Subject: Submission on the Draft Melton East Precinct Structure Plan (PSP)

**Subject:** Proposed Planning Scheme Amendment C244melt | Functional Design Review for Wetland “WRL 5”

**Subject Land :** 1292 Beattys Road, Grangefields

Figure 1 - Current functional design for WLRB5, Waterway 3Bg and Waterway 3C (Alluvium, 2025)

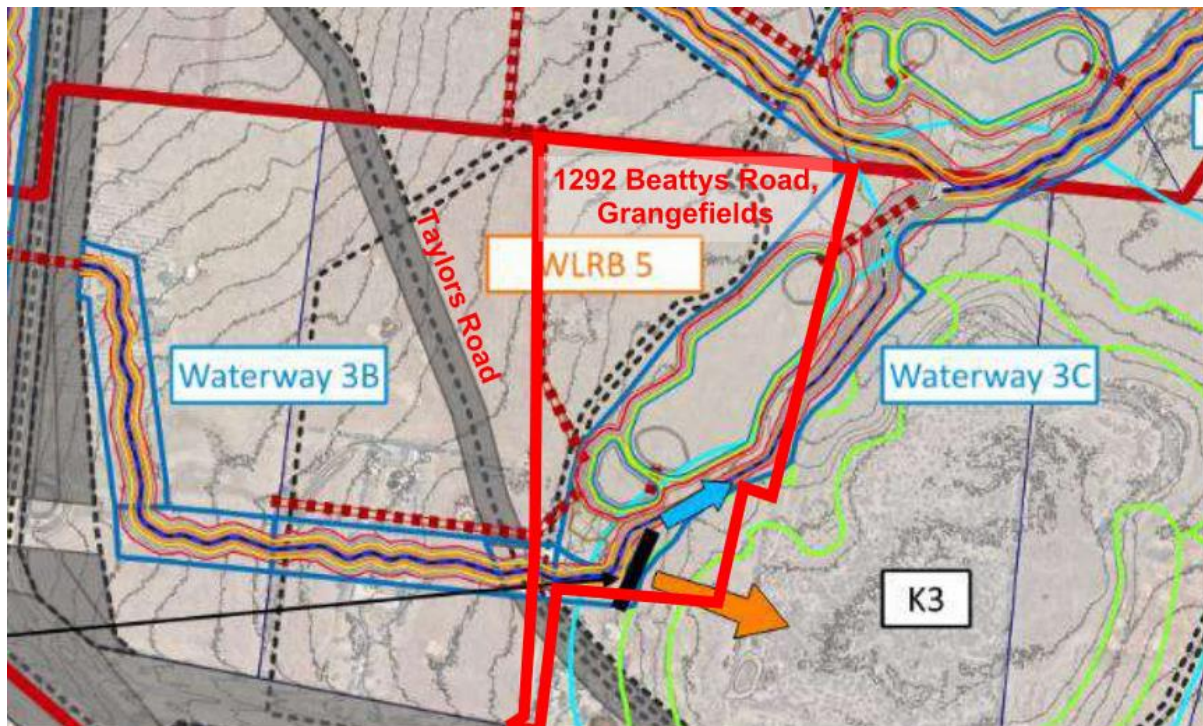
We have reviewed the *Kororoit Creek Upper and High Street Melton DSS Functional Design Report* prepared by Alluvium (February 2025), with a particular focus on the proposed stormwater infrastructure referred to as Wetland Retarding Basin “WLRB 5”, Waterway “3B” and bypass Waterway “3C” associated with the Seasonal Herbaceous Wetland (SWH) “K3” proposed to be located partly on the subject land as shown in Figure 1 below.

Based on our review of the current functional design proposed by Alluvium we generally agree with the design parameters adopted. However, we have proposed a slightly modified location for “WLRB 5” as we believe that there is a significant opportunity to utilise constrained land in the PSP and recover land more suitable for Net Developable Area (NDA).

**Figure 4: Cross-section at downstream end of “Waterway 6C”**

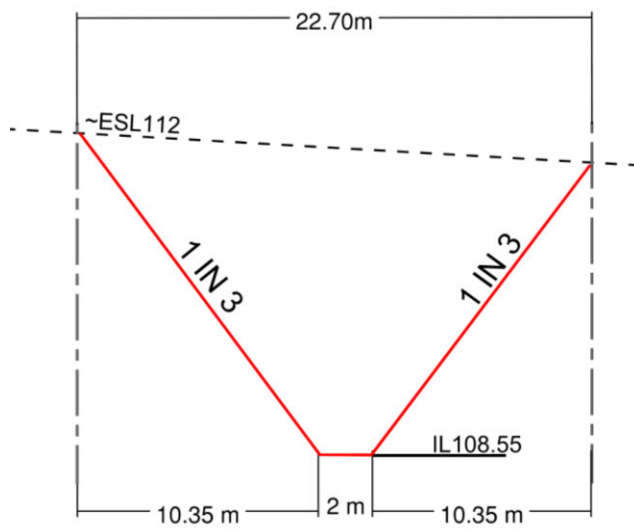
The current Alluvium design proposes a bypass waterway with a capacity of  $1.05 \text{ m}^3/\text{s}$  with a design of flow  $\geq 0.1 \text{ m}^3/\text{s}$  to replicate the wetting regime of SHW “K3”. A cross-section taken at the downstream end of waterway alignment based on the existing surface and the proposed invert levels in Alluvium’s functional design is provided in Figure 4 below.

The cross-section reveals a top width of approximately 23 metres.

However, Table 35 of the Alluvium report nominates a top width of 7.0 metres—this does not reflect the increased depth required to drain diverted flows from Waterway 3b, as indicated in the section above.

Given the relatively low magnitude of flow and the disproportionate land take, DPM proposes that Waterway “3C” is removed, re-directed and piped along the Taylors Road alignment to discharge into Waterway “5” further east of SHW “K3”. This approach conserves developable land while achieving the intended hydraulic function.

# CURRENT CONFIGURATION

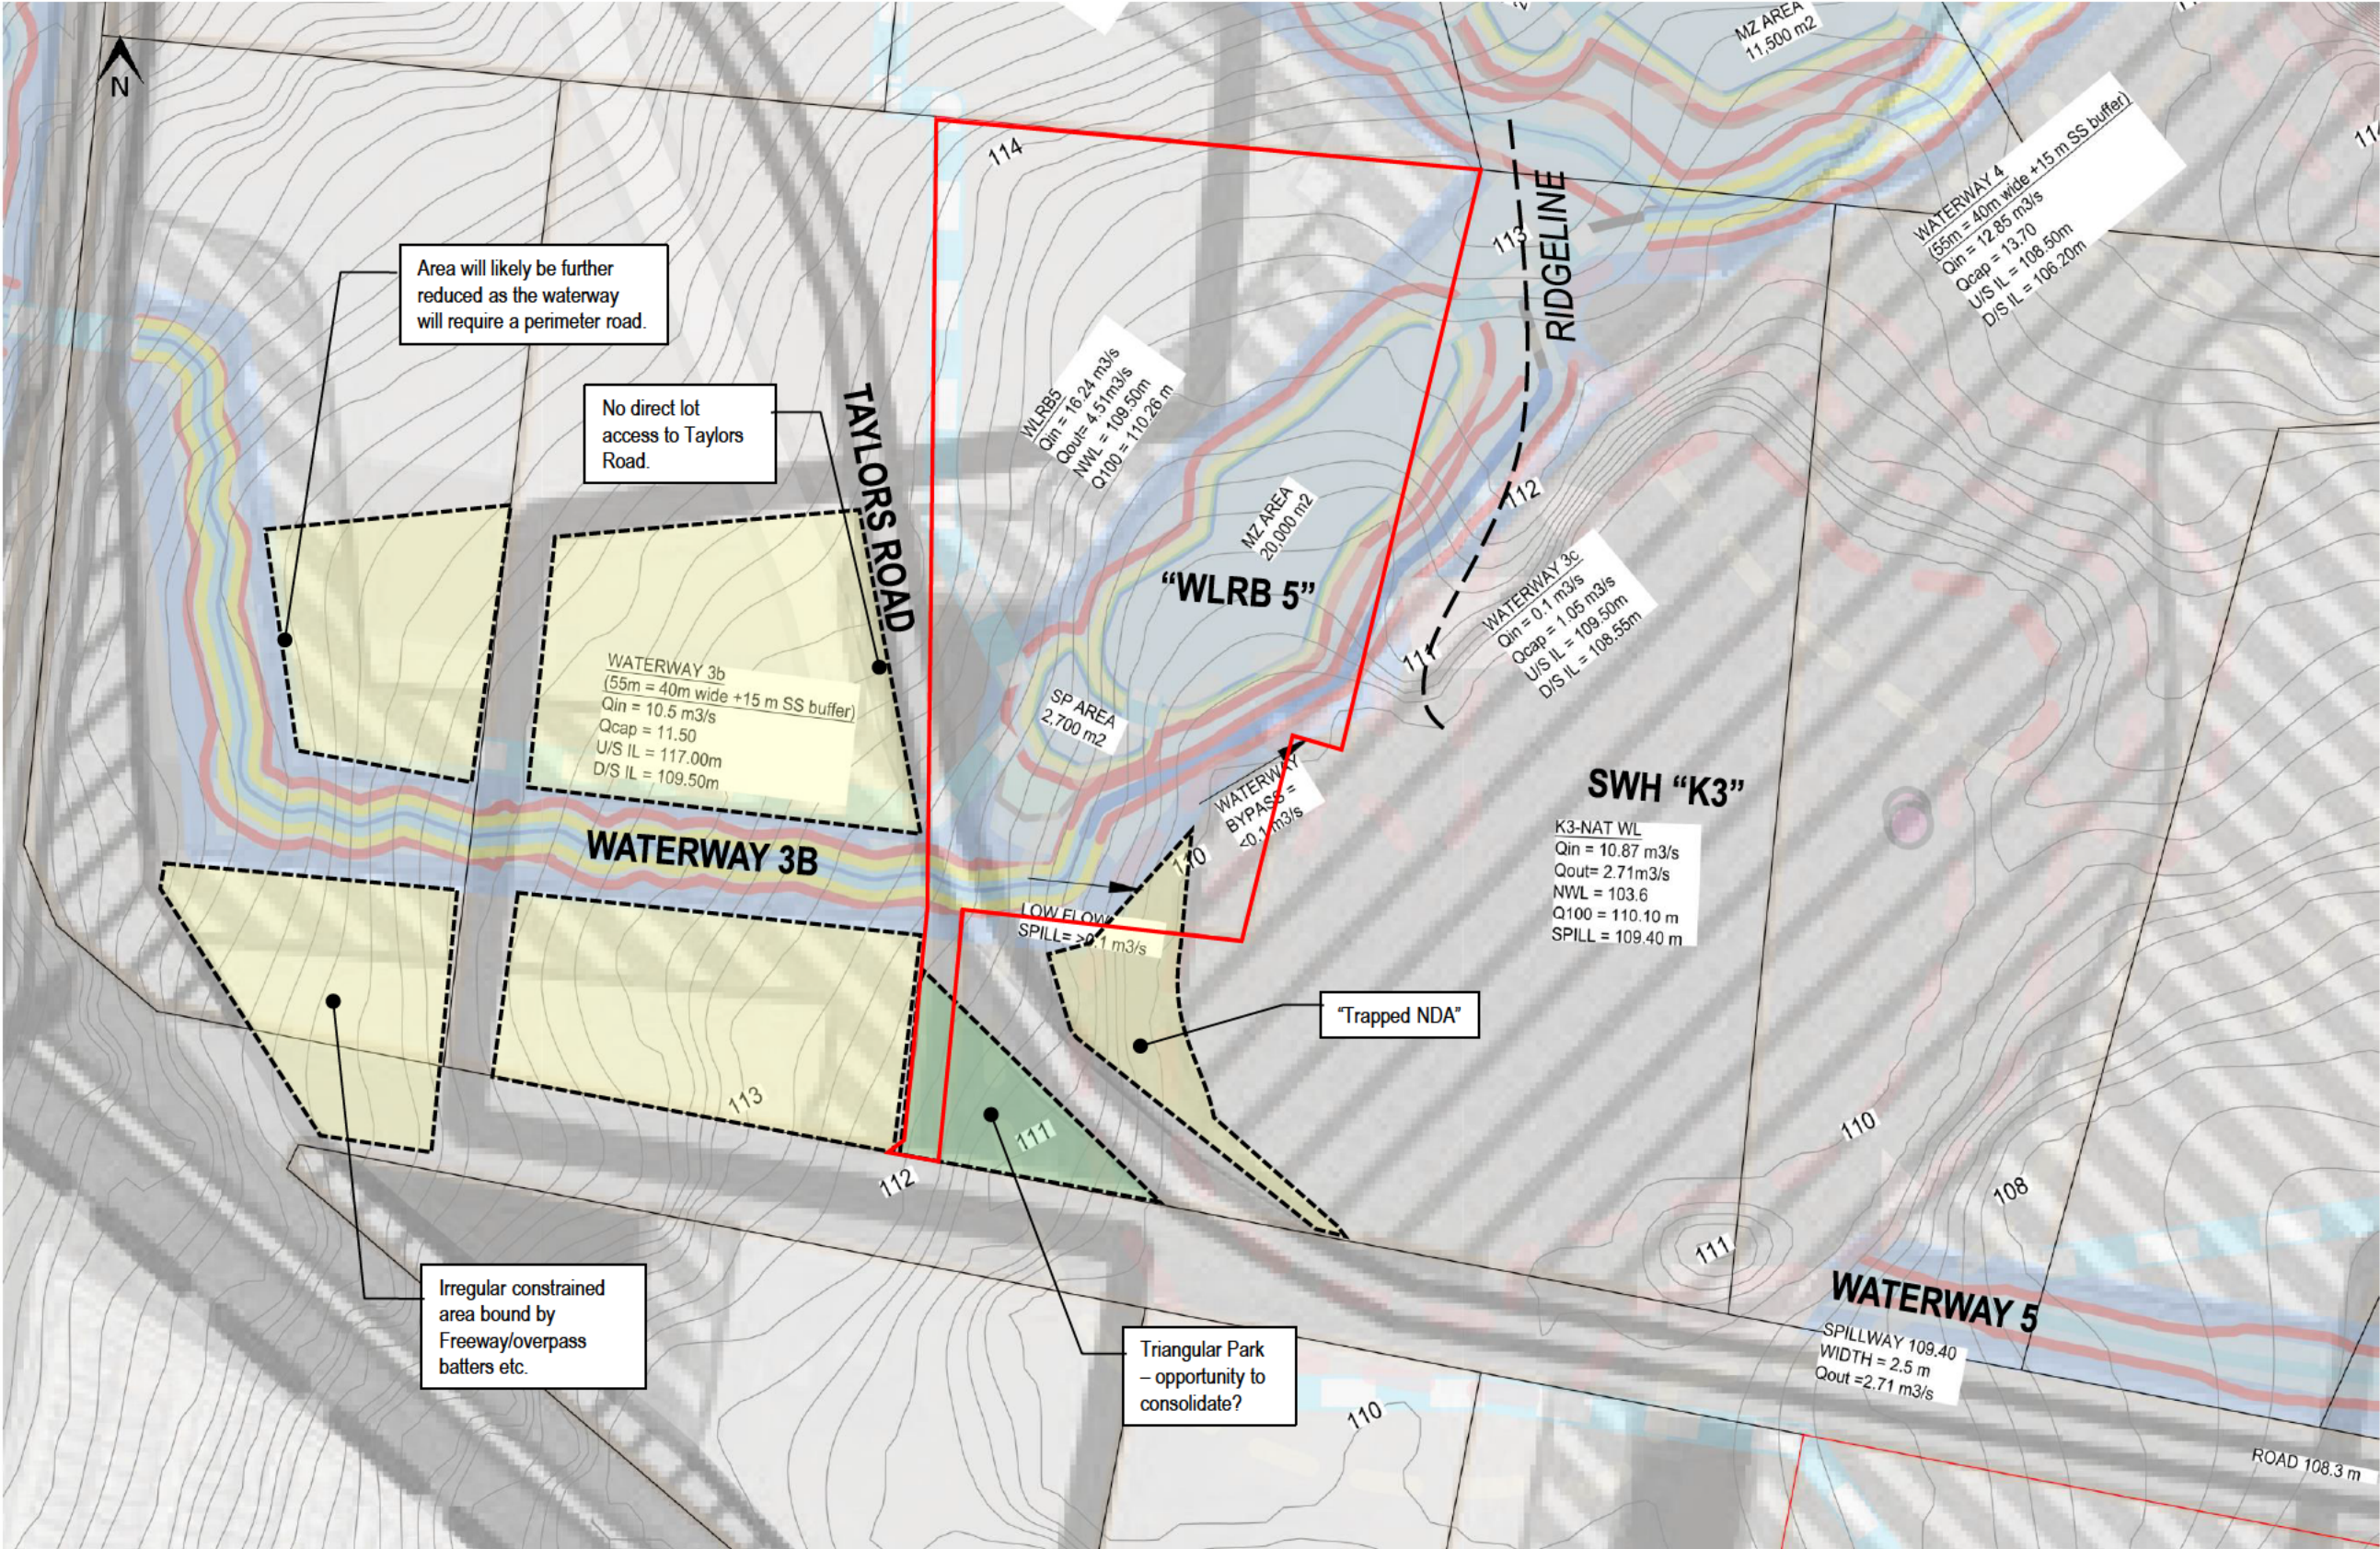
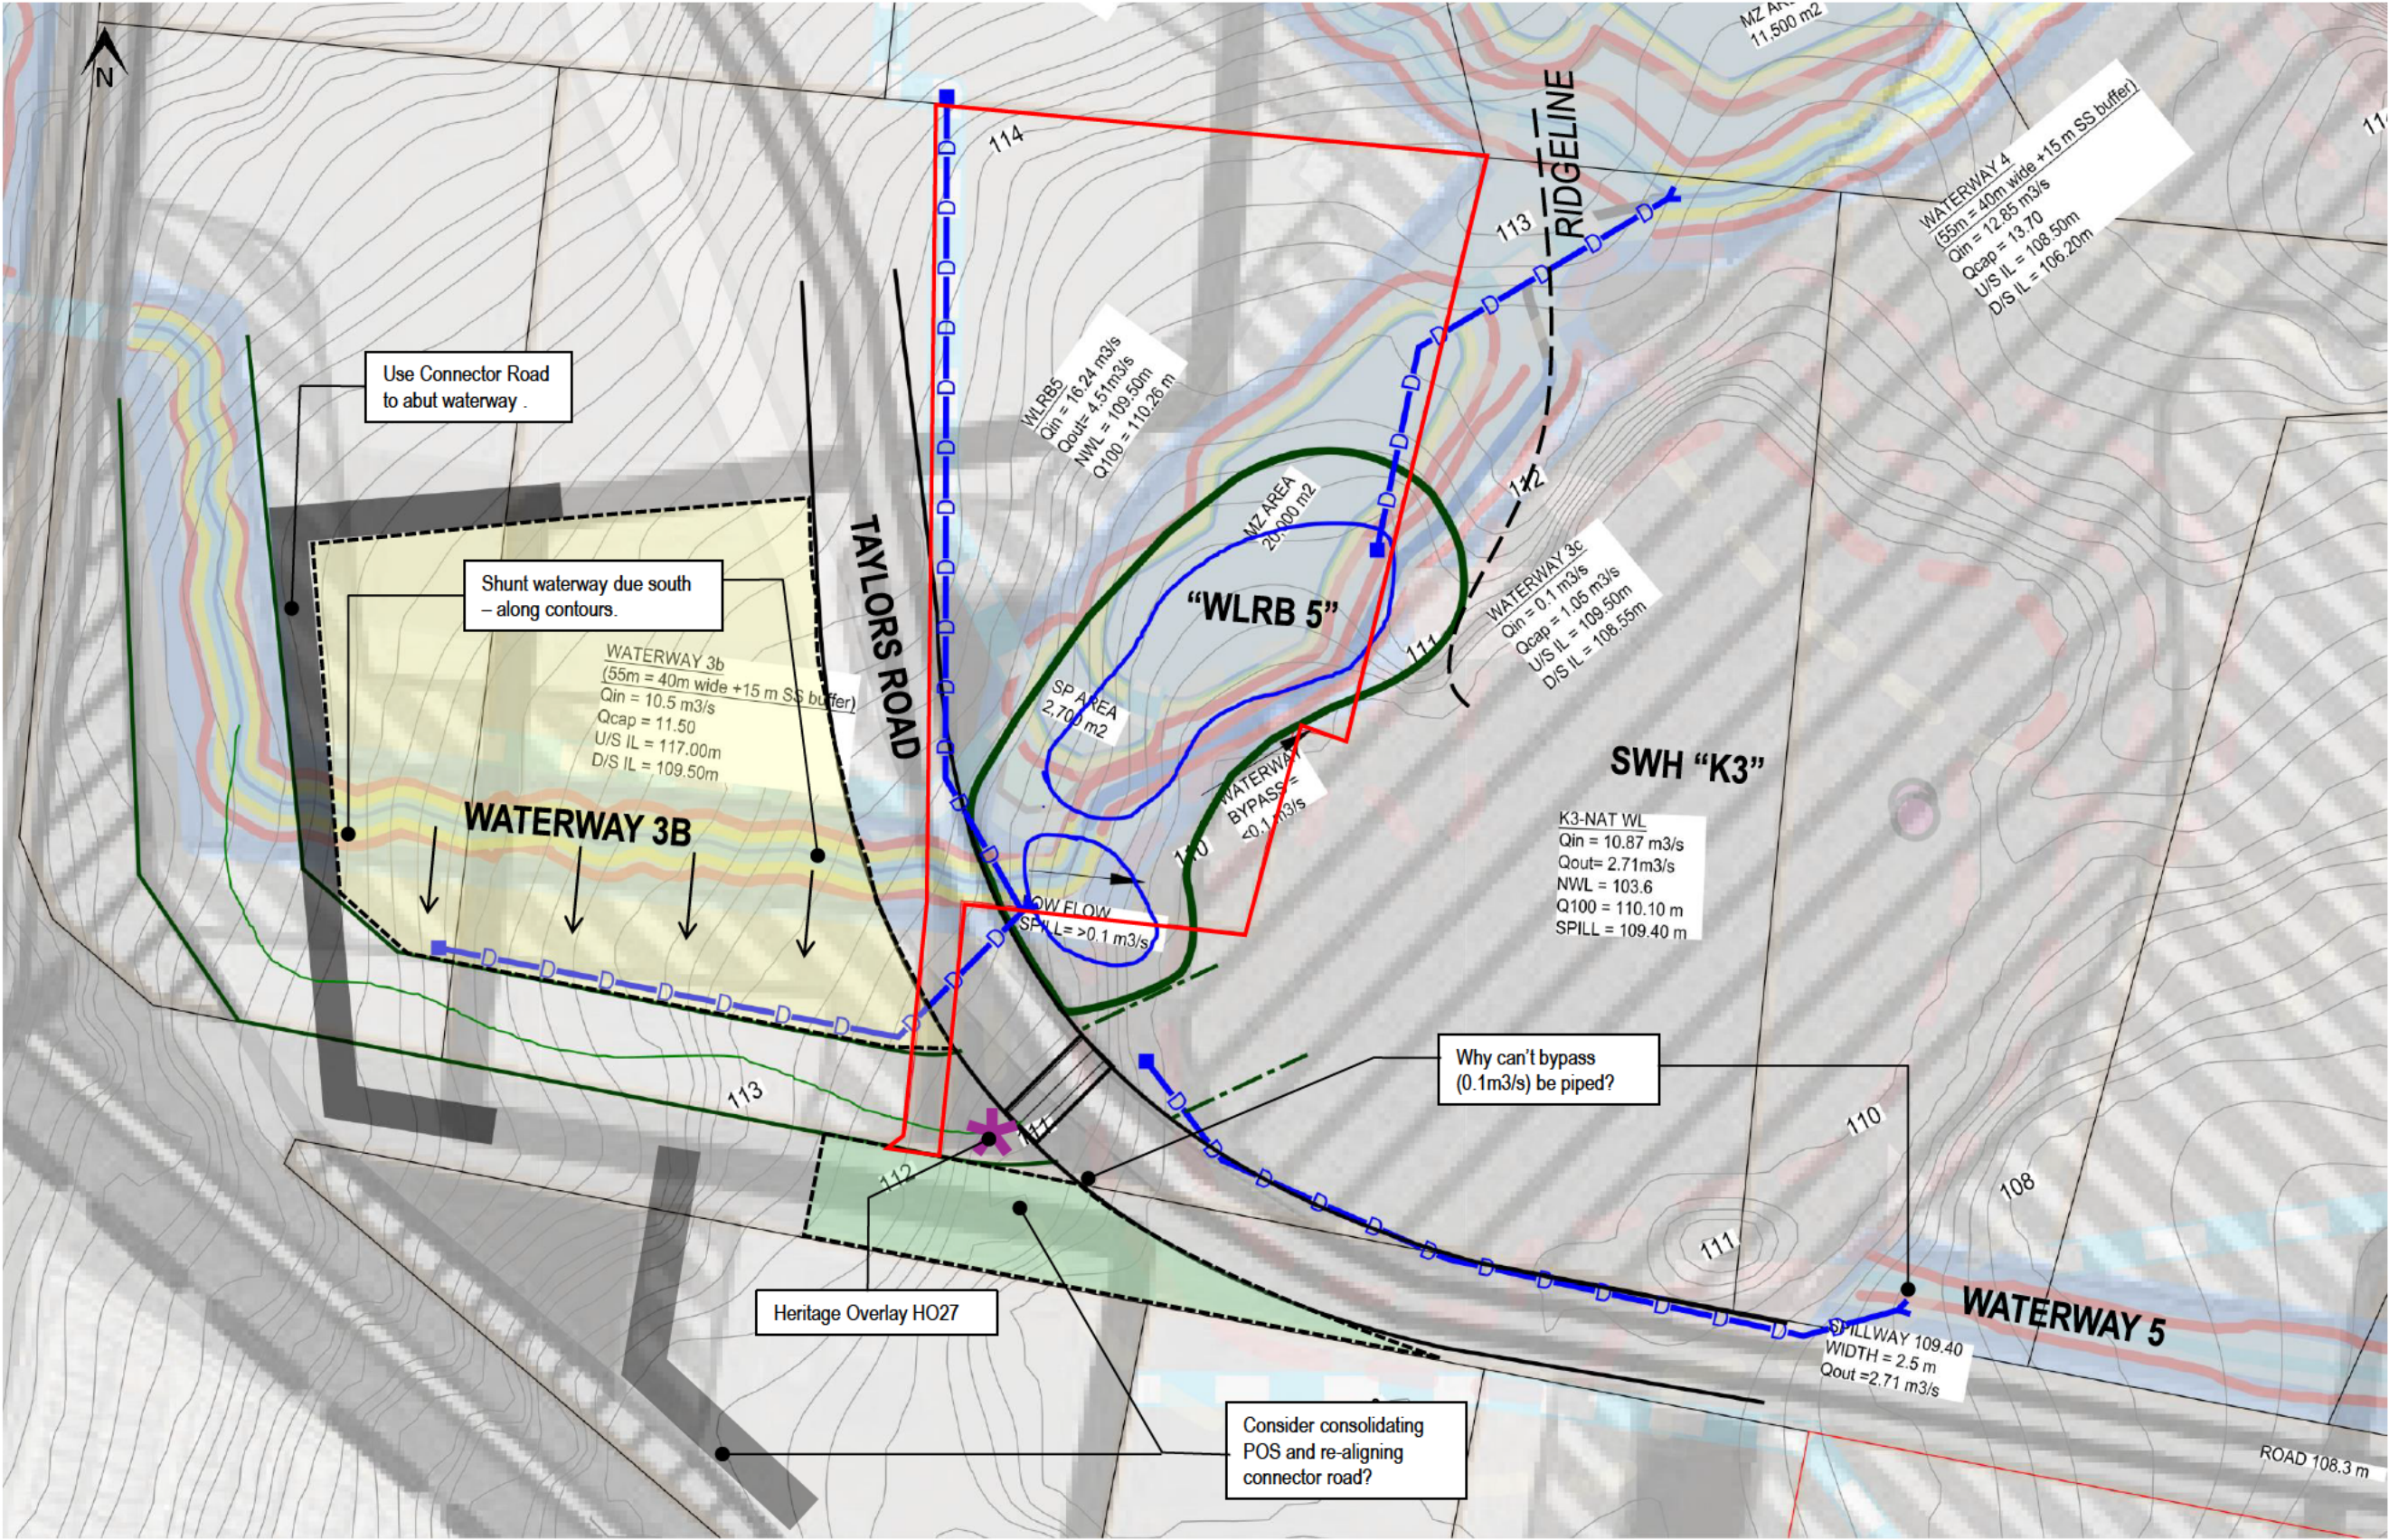
The changes proposed by DPM are founded on repositioning Wetland “WLRB5” and relocating Waterway “3B” further south of its current location. Figure 2 and Figure 3 provided further below show the current Alluvium and proposed DPM configurations, respectively.

It is submitted that wetland “WLRB 5” is repositioned to the south-east corner of the subject land, absorbing some of the “trapped NDA” between the future Taylors Road realignment and the adjacent “K3” Seasonal Herbaceous Wetland (SHW). This shift follows the direction of the natural valley. The configuration of inlet and outlet pipelines has remained consistent with the Alluvium design.

It is submitted that in conjunction with the above change, “Waterway 3B” is shifted due south to abut the former Beattys Road reservation whilst remaining perpendicular to the contours. The modified alignment retains the same hydraulic function as the Alluvium design but absorbs the residual “trapped NDA” left from relocating Wetland WLRB5. Importantly, this alignment has been carefully designed to avoid any encroachment into the proposed Heritage Overlay HO27, which applies to the Nissen Hut at 1232–1290 Beattys Road.

The combination of the above changes to the PSP's stormwater infrastructure, provides the opportunity to enhance the urban layout to the west of Taylors Road as illustrated in Figure 3 by making the below key changes to the road network:

- Re-align the Connector Road to abut the waterway, this would have otherwise been required by local road.
- Re-align the Connector Road south of Taylors Road to create space for a more regular and linear park reserve that can be co-located with the proposed Heritage Overlay (HO27).
